LUFTDYKTIGHETSPÅBUD (LDP)

ROBINSON - 1

1056/90 MODIFIKASJON AV LUFTFILTERHUS

VEDLEGG 1 TIL LDP 056/90

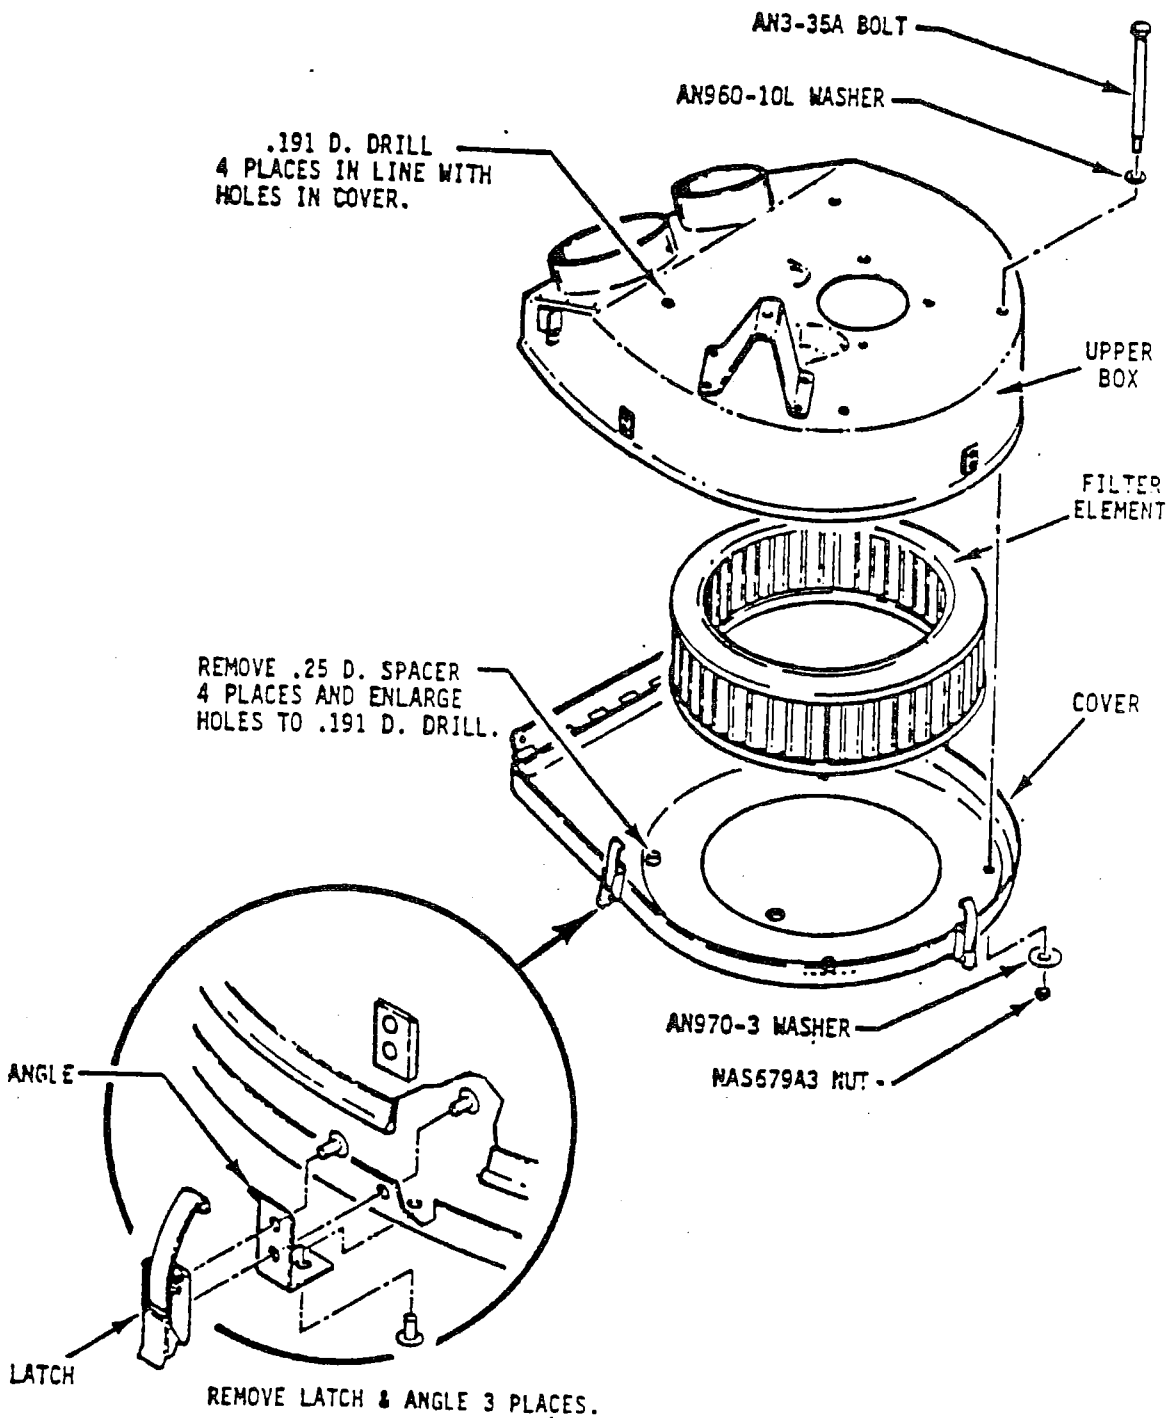
1. Fjern de tre festeklemmene, og erstatt disse med fire bolter i samsvar med følgende fremgangsmåte, ref. vedlegg 1 til denne LDP:
 - 1.1 Åpne filterhuset og fjern luftfilterelementet.
 - 1.2 Demonter filterhuset fra helikopteret.
 - 1.3 Bor ut de fire naglene i dekselet som holder de 0.25" (6.35 mm) tykke avstandsstykkene og øk hullenes diameter til 0.191" (4.85 mm). Avstandsstykkene kasseres.
 - 1.4 Lukk igjen dekselet, og ved å benytte hullene i dekselet som styring bores fire tilsvarende hull gjennom det øvre huset på linje med hullene i dekselet.
 - 1.5 Åpne luftfilterhuset og bor ut naglene som fester klemmene til huset. Kasser klemmene og rengjør filterboksen.
 - 1.6 Monter luftfilterhuset på helikopteret.
 - 1.7 Installer filterelementet og sikre dekselet ved å benytte fire AN3-35A bolter, AN960-10L skiver, AN-970-3 skiver og NAS679A3 mutre.

Figure 1

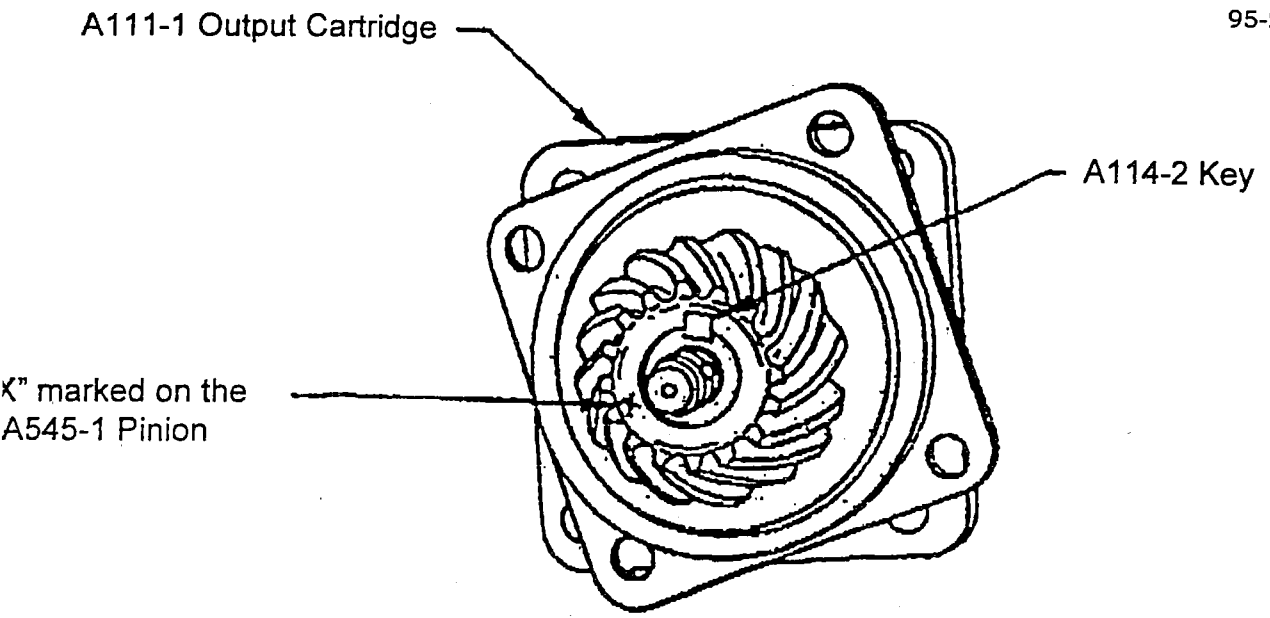
(4) Remove and disassemble the output cartridge, P/N A111-1, from the T/R gearbox case, P/N A109-1 (see figure 1) as follows:

(ii) Cut and remove the safety wire around the four MS20074-04-06 bolts securing the output cartridge to the gear case. Remove and retain each of the four bolts and their associated AN960-416L washer(s), noting the washer stacks for reassembly. Separate the output cartridge from the gear case (see figure 1).

(ii) Cut and remove the safety wire around the four MS20074-04-06 bolts securing the input cartridge to the gear case. Remove each of the four bolts and their associated AN960-416L washer(s), noting the washer stacks for reassembly. Separate the input cartridge from the gear case (see figure 1).

(iii) Secure the input cartridge to a block of wood through the two bolt holes in the input shaft assembly, P/N A116-1 (see figure 1). Place the block of wood in a vise. Remove and discard the safety wire, roll pin, and retaining nut. Remove the AN960-616L washer(s), and washer, P/N A141-1, noting the washer(s) location for reassembly. Do not damage the input shaft or shim(s), P/N A118-1 through -6, located next to the flange of the input cartridge.

Figure 3

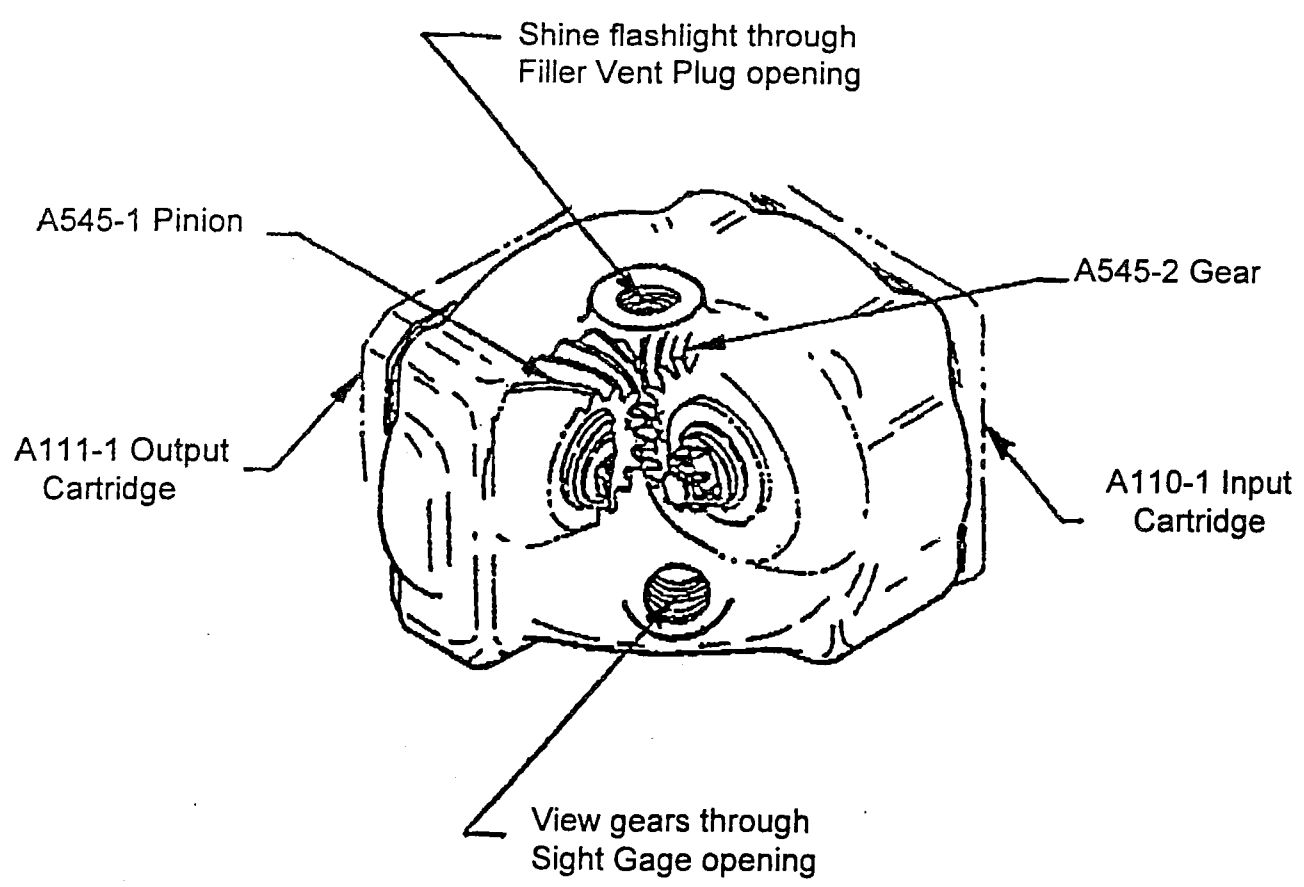
(i) Color the "X" marked on the pinion gear, P/N A545-1, (one tooth only) of the output cartridge and on the gear, P/N A545-2, (located on two consecutive teeth) of the input cartridge with a red marker to make reinstallation easier. Note that these three gear teeth may already be colored (see figure 3).

(v) Look through the sight gage opening while using a flashlight pointed into the filler vent hole to verify the gears are meshed properly. Gears are properly meshed when the "X" marked on the pinion gear of the output cartridge is between the two "X's" marked on the gear of the input cartridge (see figure 3). Do not torque the MS20074-04-06 bolts until both cartridges are installed on the case and the gears are properly meshed. Torque the output cartridge bolts to 60 in.-lbs. first, then torque the input cartridge bolts to 60 in.-lbs. Safety wire with 0.032-inch stainless steel safety wire.

Figure 4

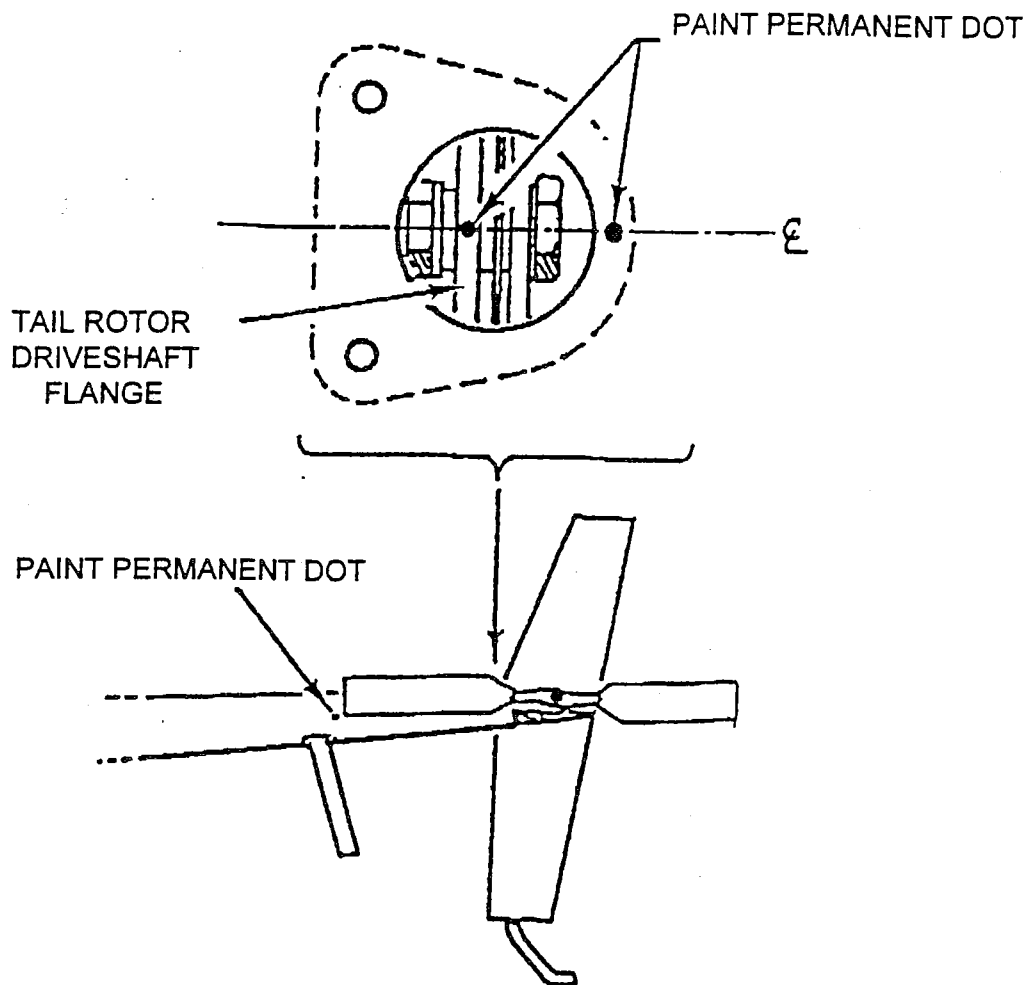
(a) Before further flight, install alignment dots as follows: Remove the transparent inspection cover on the tail cone and rotate the T/R blades so that one blade leading edge is aligned with the tail cone centerline. Mark a dot on the tail cone skin aligned with the tip of the blade leading edge. With the same alignment, mark a dot on the centerline of the tail cone skin at the edge of the inspection hole, and mark a corresponding dot on the drive shaft flange (see figure 4).

FIGURE 1

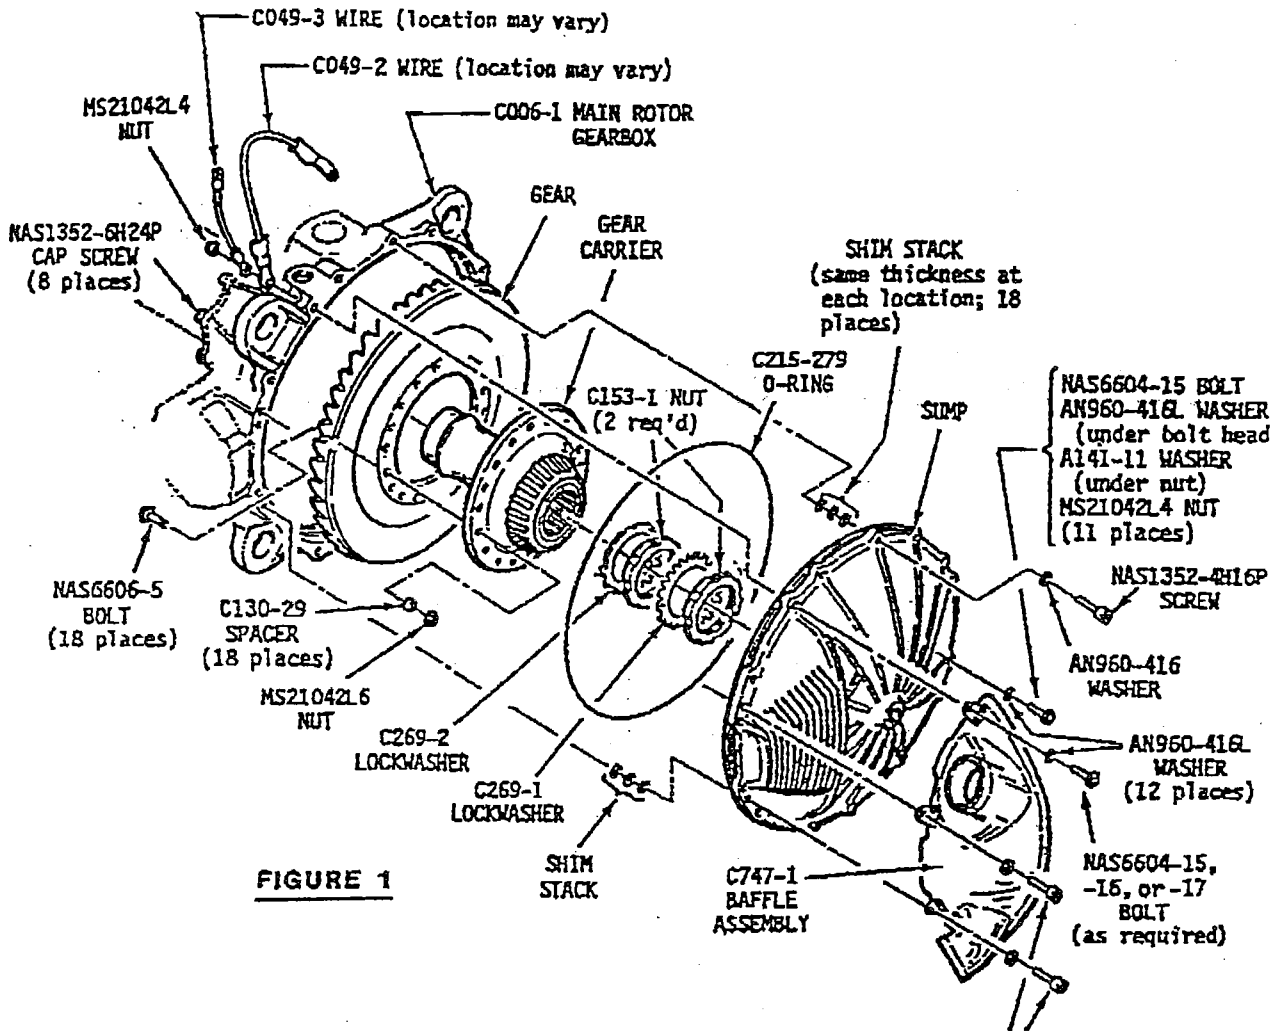
- (a) Drain the oil from the gearbox, part number (P/N) C006-1, and remove the gearbox from helicopter.
- (b) Lay the gearbox on its side with input yoke up. Loosen the eight cap screws attaching the mast tube to the gearbox, but do not remove the screws. Remove the twelve bolts and six cap screws holding the sump and baffle in place (Figure 1). Note the location of ground wires.

FIGURE 2

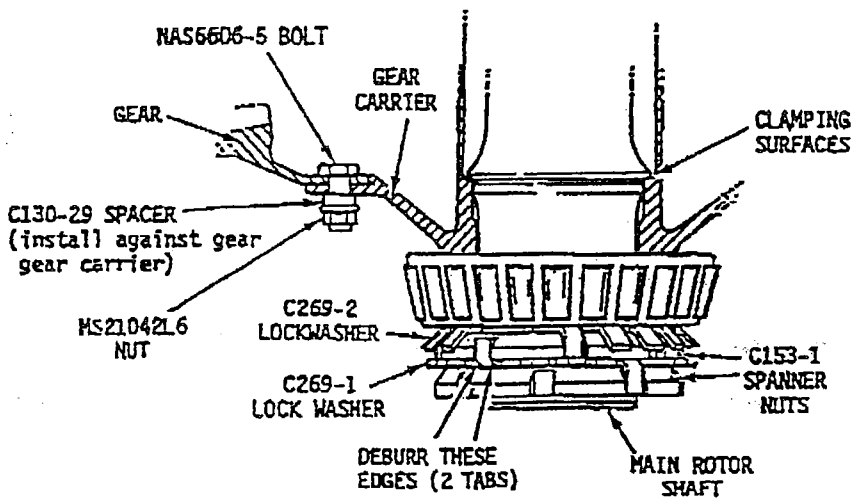
- (h) Align the gear to the gear carrier and install NAS6606-5 bolts, spacers, P/N C130-29, and MS21042L6 nuts in 18 places (Figure 2). Keep the mating surfaces and hardware dry, clean, and free of oil. Torque the nuts to 40 ft.-lb. (includes self-locking torque) using the torquing sequence shown on Figure 3.

- (l) Before installing the unused lockwasher, P/N C269-1, note that the edges are sharp on one side and rounded on the other. De-burr the sharp edges on two opposite tabs (Figure 2). This will reduce the chance of cracking when these tabs are bent. Install the lockwasher with the de-burred edges toward the first nut.

Figure 1
PL AD 98-12-19

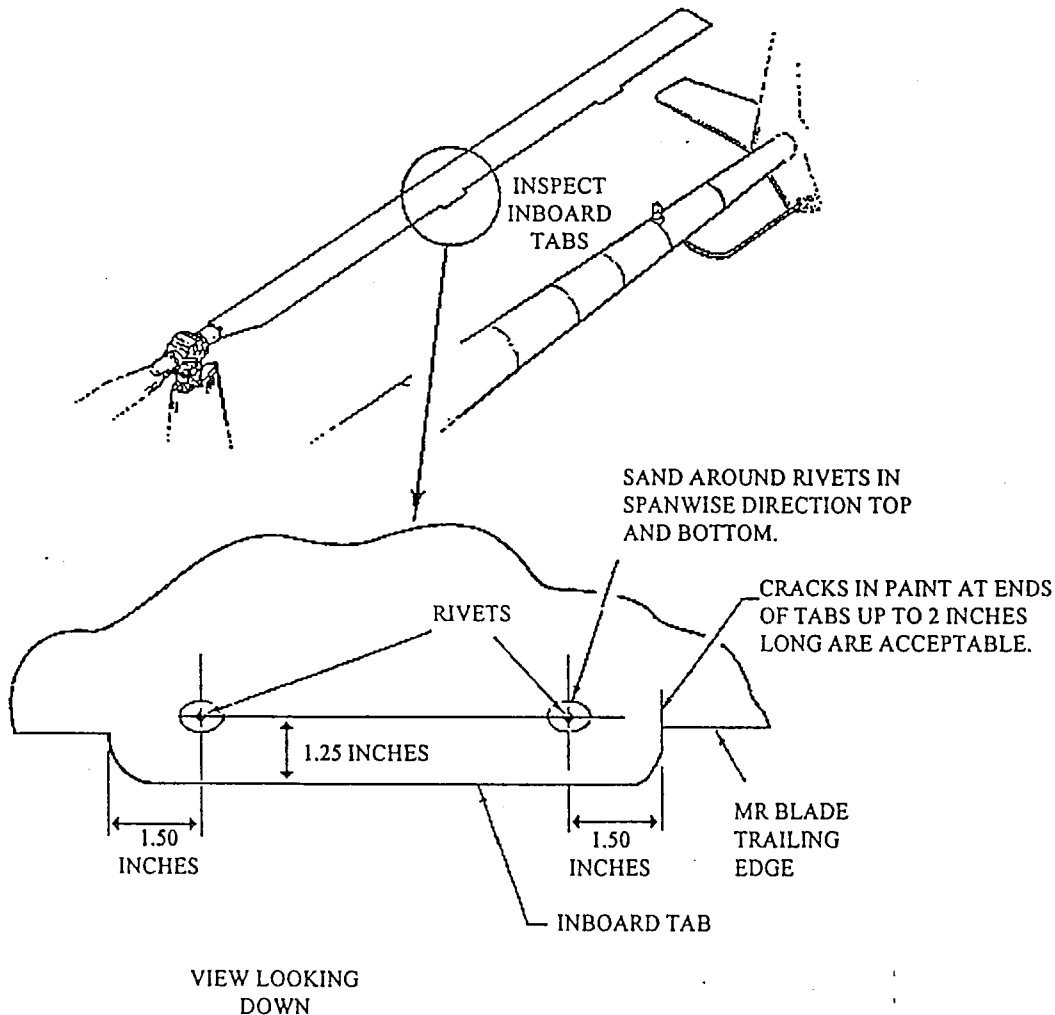
(a) Within the next five hours time-in-service (TIS), perform a dye penetrant inspection of the blade skin around both inboard trim tab alignment rivets as follows, referring to Figure 1.

FIGURE 1
AD 98-21-09

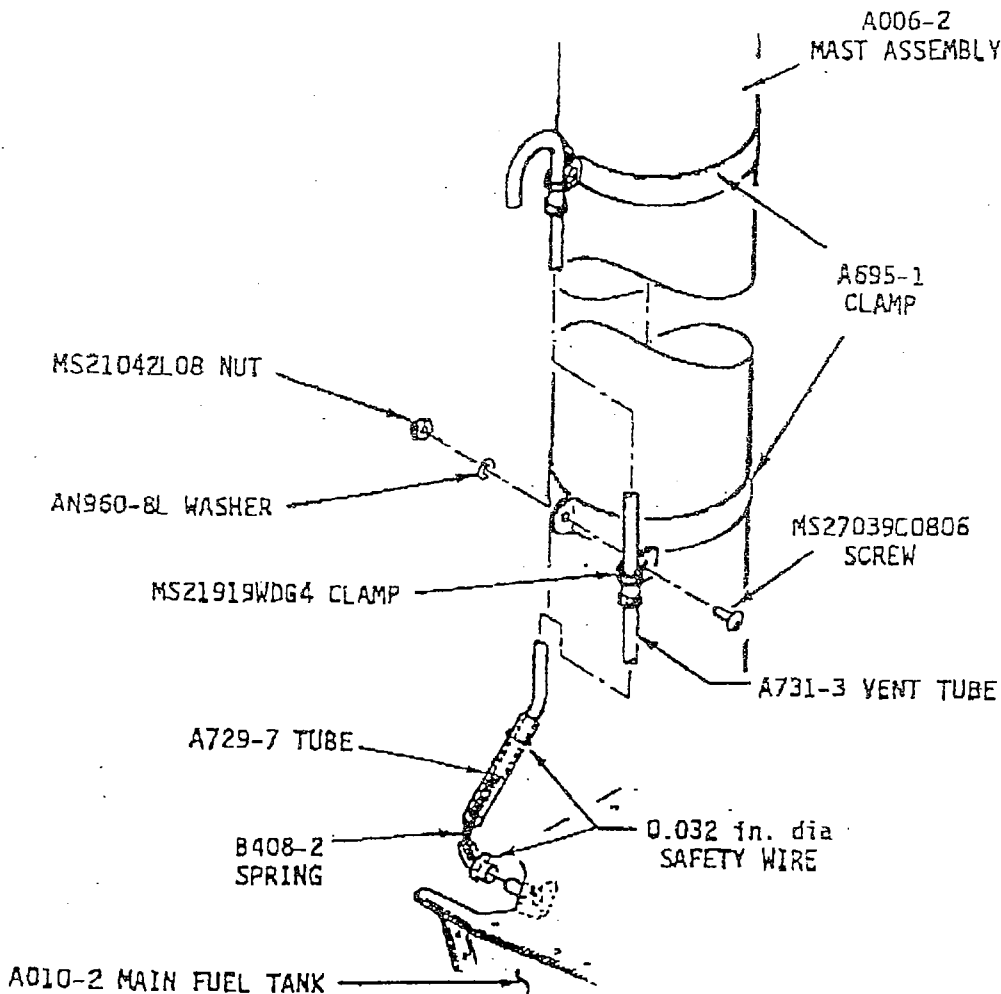
(1) For helicopters without an auxiliary fuel tank installed, remove the existing vent tube, P/N A731-1, and install an airworthy vent tube, P/N A731-3, with flexible tube, P/N A729-7, using a MS27039C0806 screw and AN960-8L washer (alternate P/N NAS1149FN816P) at the lower clamp, P/N A695-1 (see Figure 1).

FIGURE 2
AD 98-21-09

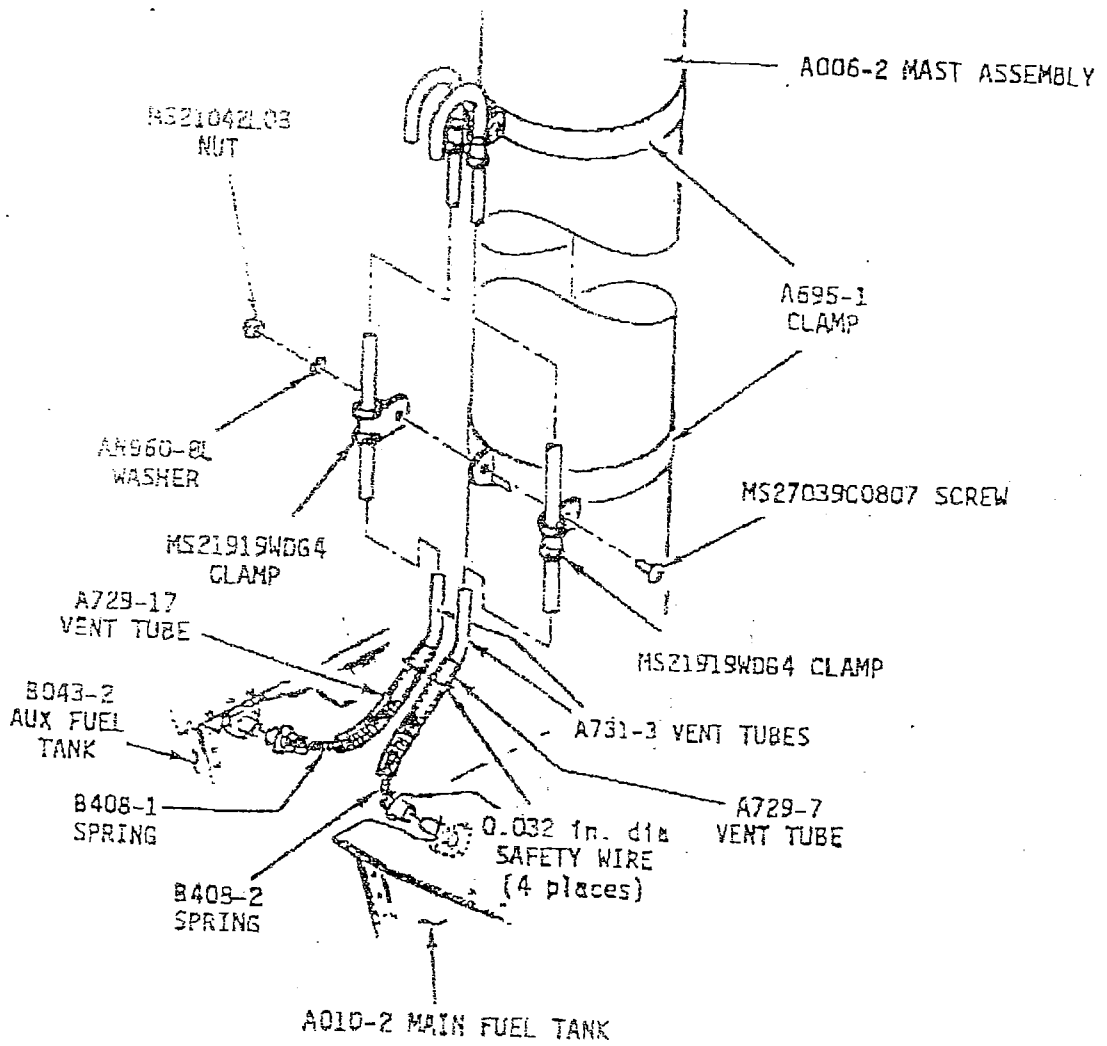
(2) For helicopters with an auxiliary fuel tank installed, remove the existing main fuel tank vent tube, P/N A731-1, and auxiliary fuel tank vent tube, P/N A731-2, and install airworthy vent tubes, P/N A731-3, with flexible tube, P/N A729-7, for main tank and flexible tube, P/N A729-17, for auxiliary tank using MS27039C0807 screw and AN960-8L washer (alternate P/N NAS1149FN816P) at lower clamp, P/N A695-1 (see Figure 2).
